Wichita-Sedgwick County Metropolitan Area Planning Department

Re: CON2002-00051: An administrative adjustment to Condition #4 of CON2002-00018.

VOICE STREAM
PARKING LOT EXPANSION
PROJECT NAME

ELECTRICAL SITE PLAN
SHEET TITLE

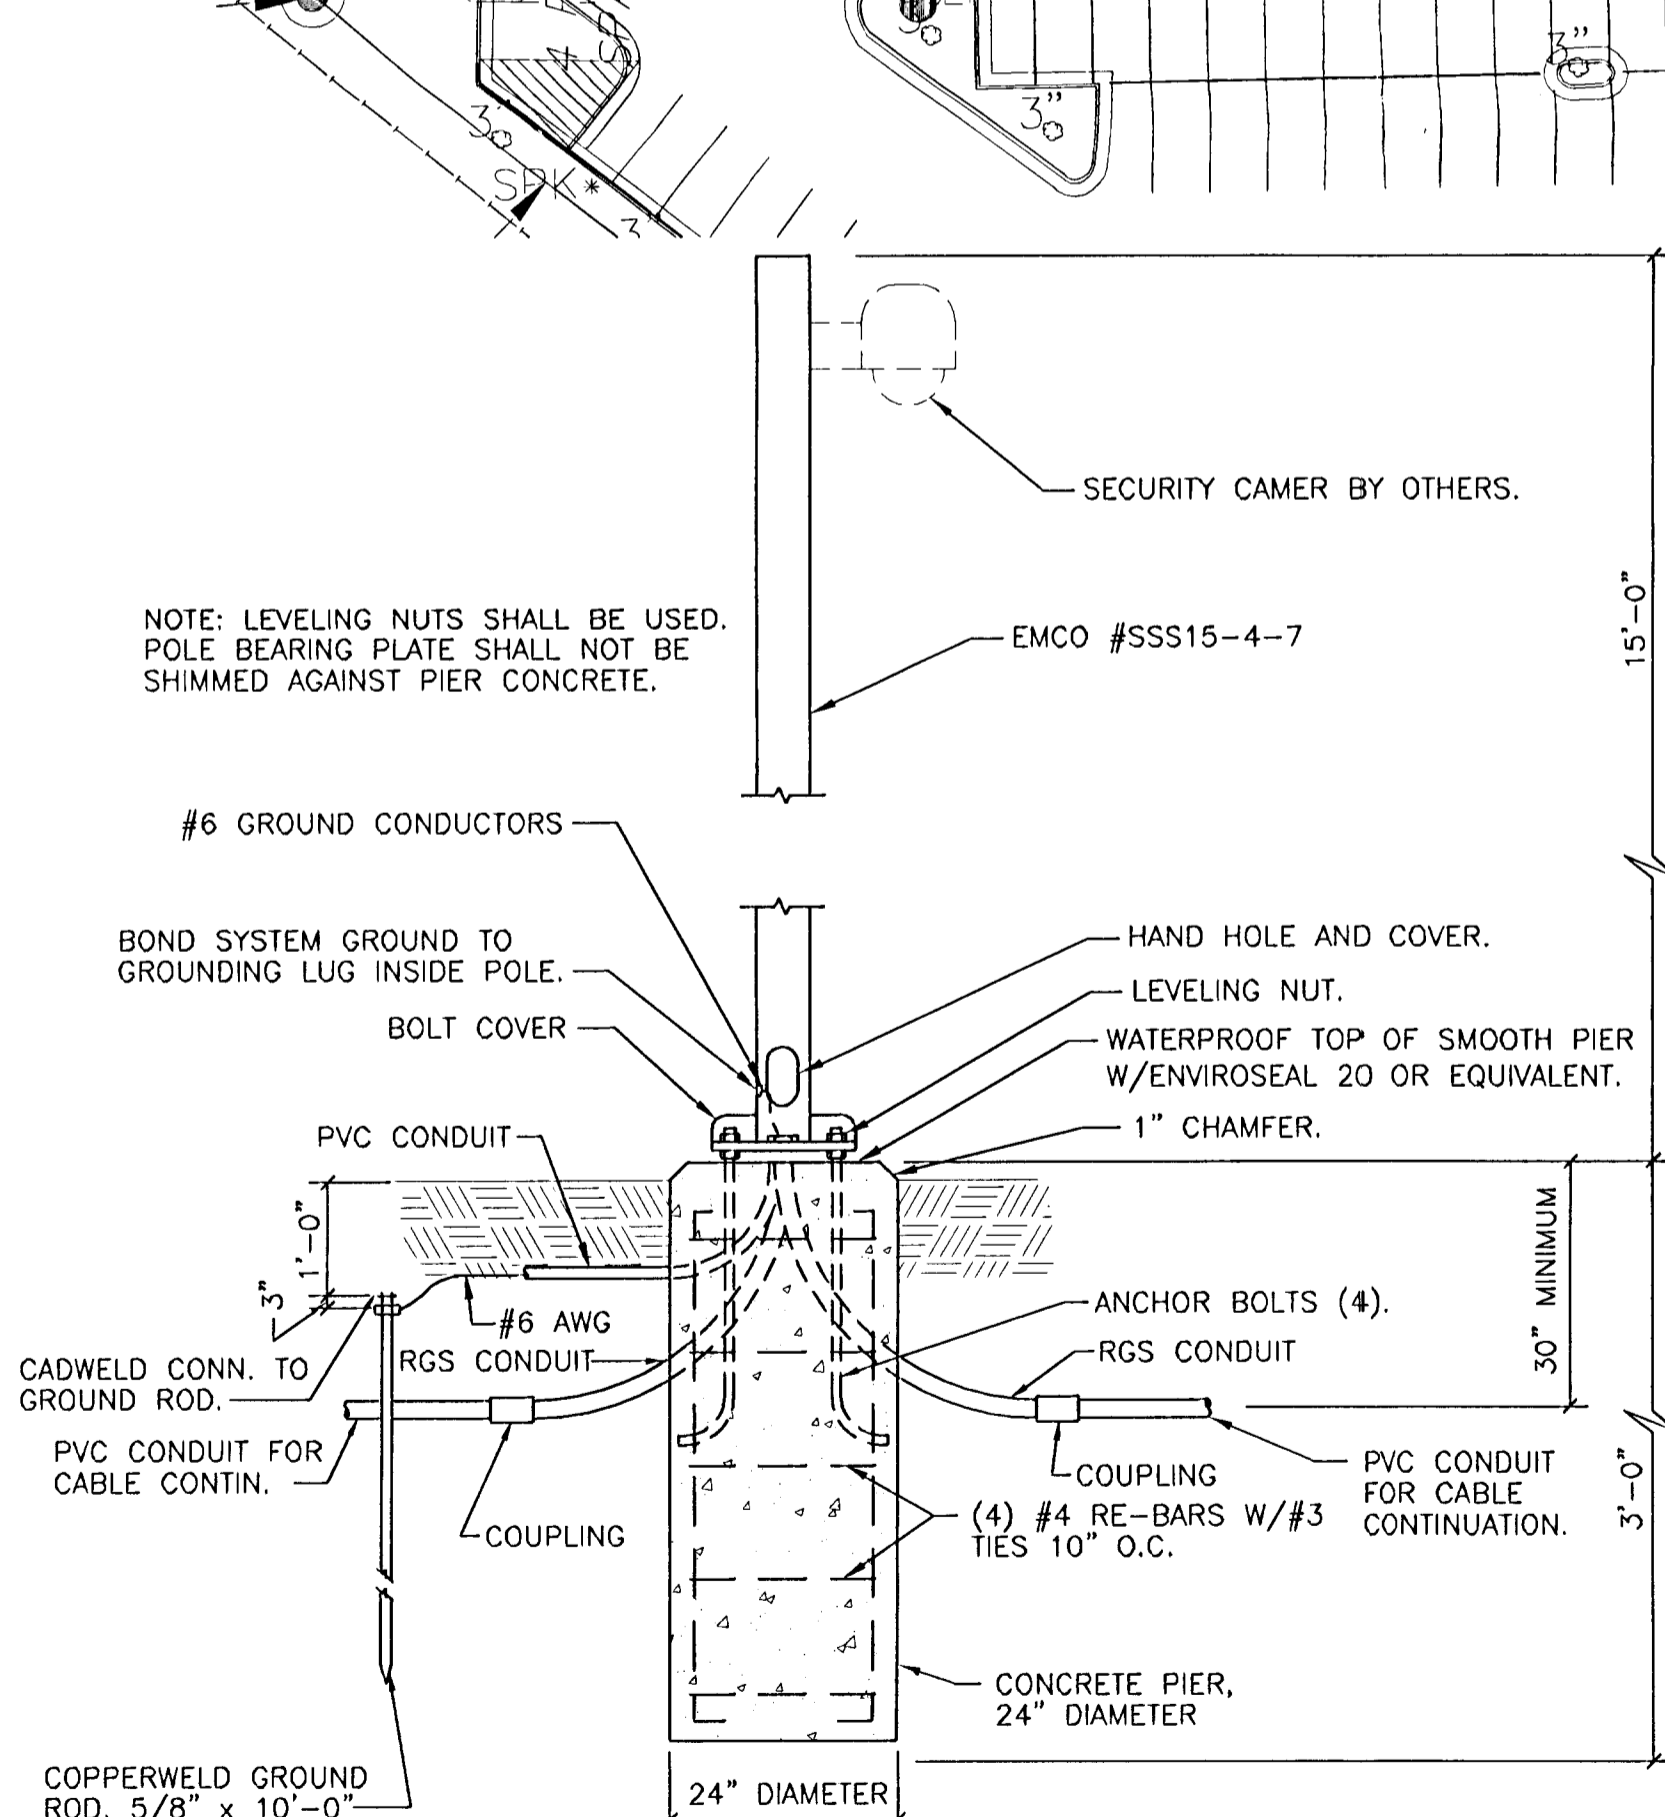
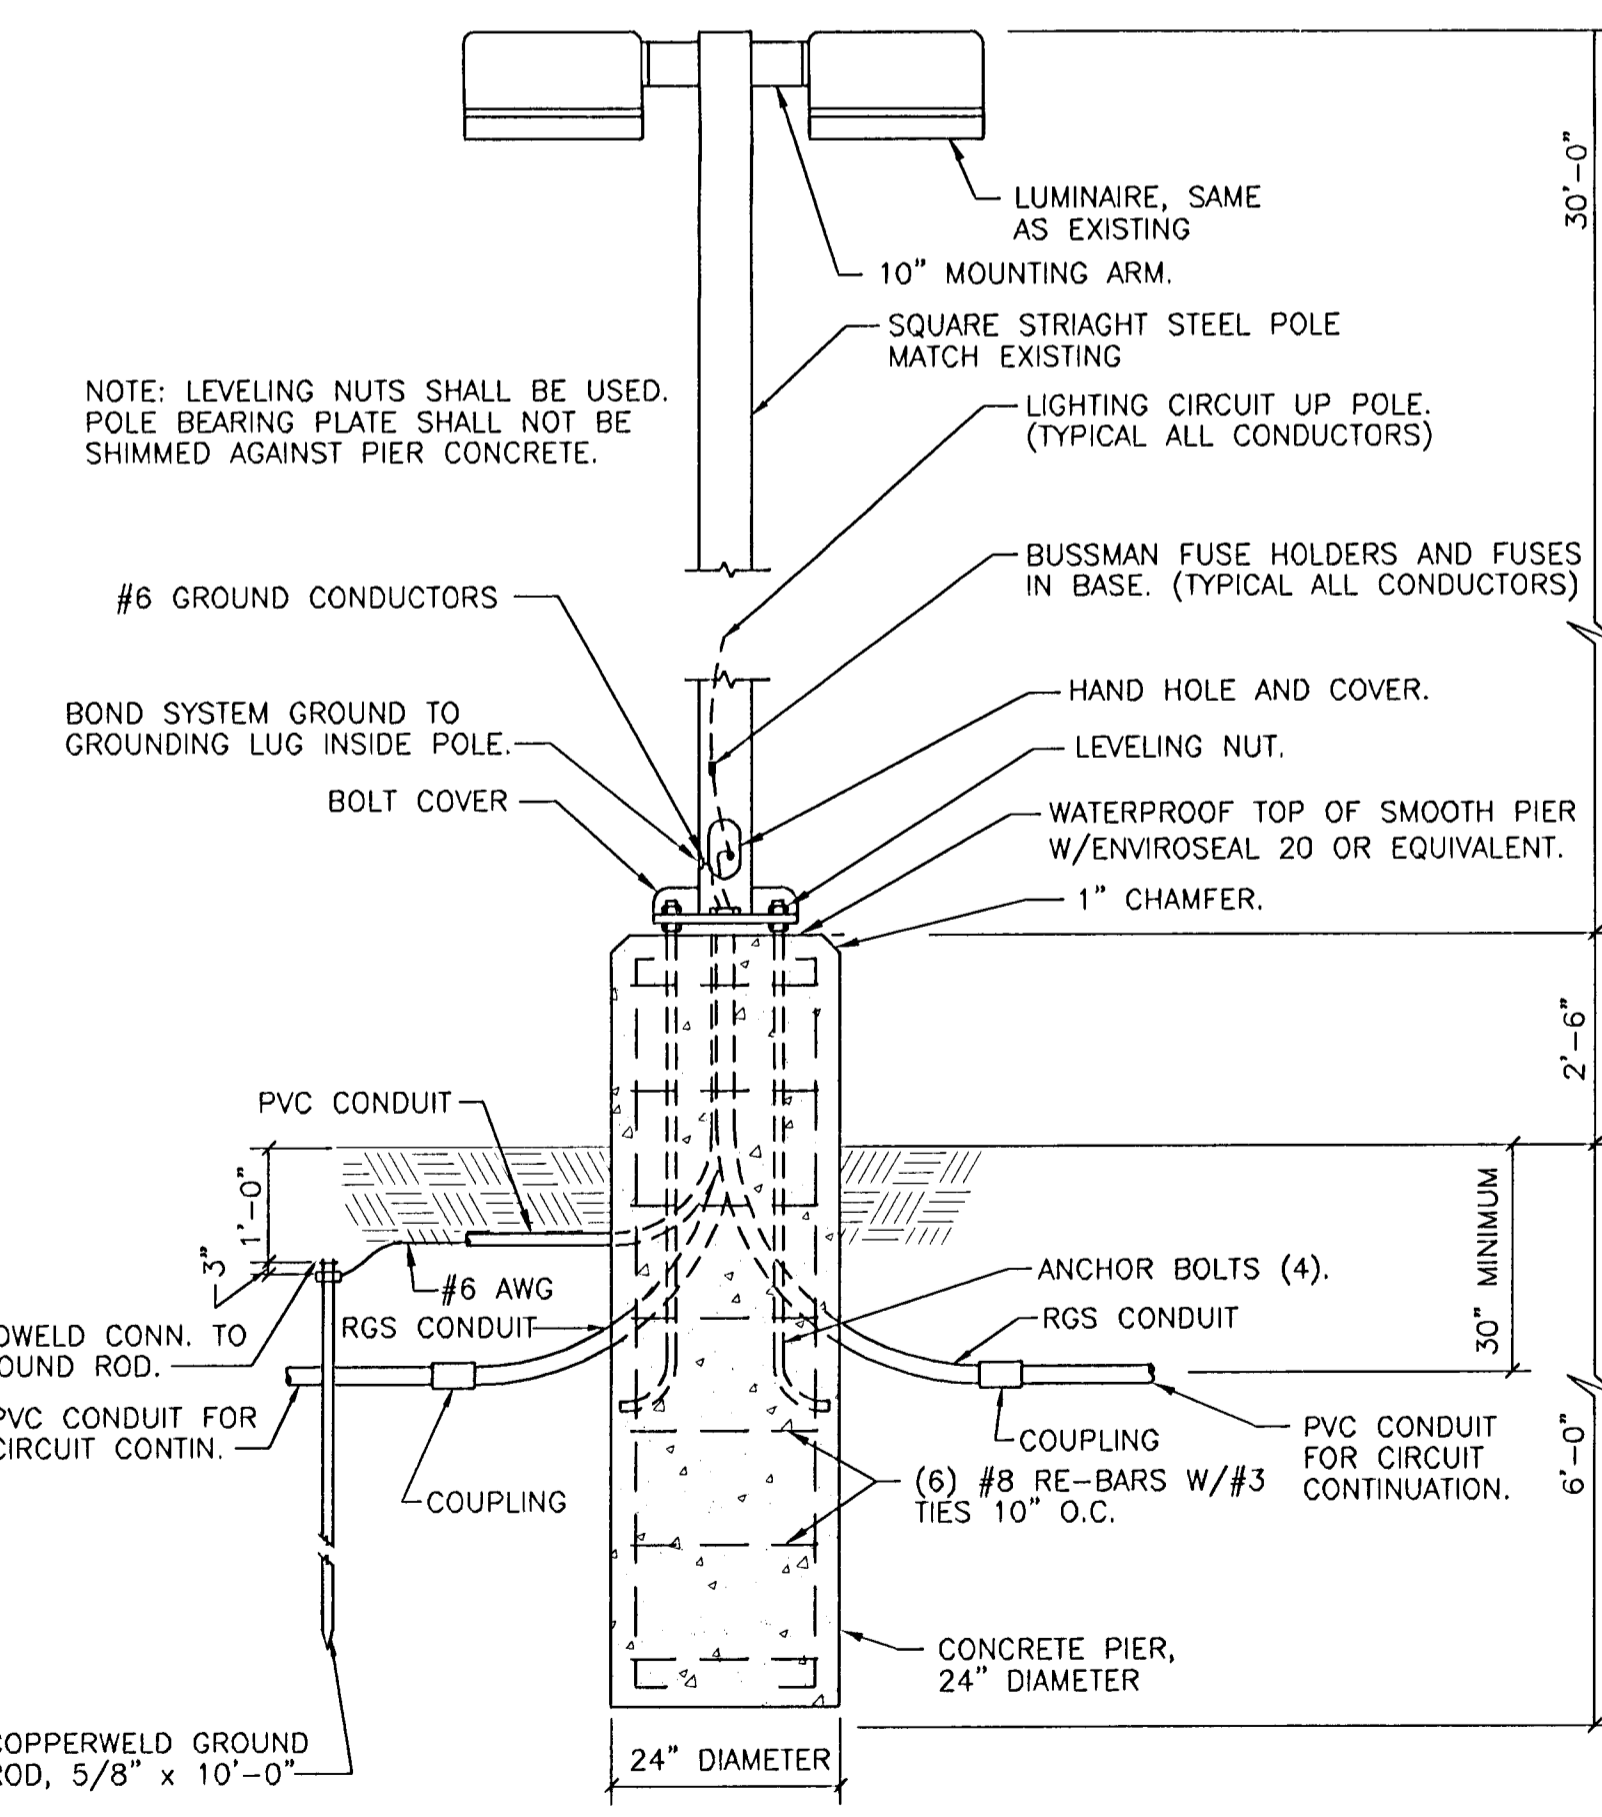
We have reviewed your request for an administrative adjustment to the site plan for CON2002-00018. You state in your application that you desire to adjust Condition #4 to increase the height of light poles and fixtures from a maximum height of 14 feet to a maximum height of 30 feet. The light poles would be placed in the center of the parking lot and be located no closer than 70 feet from the property line of residential zoning.

- 1) Impact on safety and convenience of vehicular and pedestrian circulation: The use of taller light poles and fixtures is intended to increase the safety of the parking lot for the patrons.
- 2) Impact on existing uses in surrounding areas: The taller light poles and fixtures would be located in the center of the lot by a distance of at least 70 feet to any residential property line.

This exceeds the minimum distance from a residential lot line of 60 feet for a 30-foot pole required by the Unified Zoning Code. Additionally, the adjusted landscape plan and concurrent adjustment of Condition #2 of this Conditional Use, provides for a denser landscape buffer along the north, east and west property line, which should further mitigate negative impacts on surrounding residential areas.

Our signatures below indicate that an administrative adjustment to CON2002-00018 Condition #4 to increase the height of light poles and fixtures to 30 feet on the aforementioned property is hereby granted subject to the following conditions:

- 1) Any poles and fixtures higher than 14 feet shall be at least 70 feet from any property line zoned for residential use.
- 2) Condition #2 shall be adjusted to require a landscape buffer along the screening wall on the north and east property lines to be increased to one tree every 30 feet, with at least one-half being evergreen, and an additional three evergreen trees shall be added to the northern 80 feet of the drive aisle on the western property line of the parking lot.
- 3) The lighting shall meet all other standards of Unified Zoning Code Article IV, Section IV-B.4.
- 4) The site shall be developed in general conformance with the site plan.
- 5) All conditions of approval, as modified by this adjustment, for CON2002-00018 shall be met.
- 6) Any violation of these conditions shall render the Administrative Adjustment null and void.
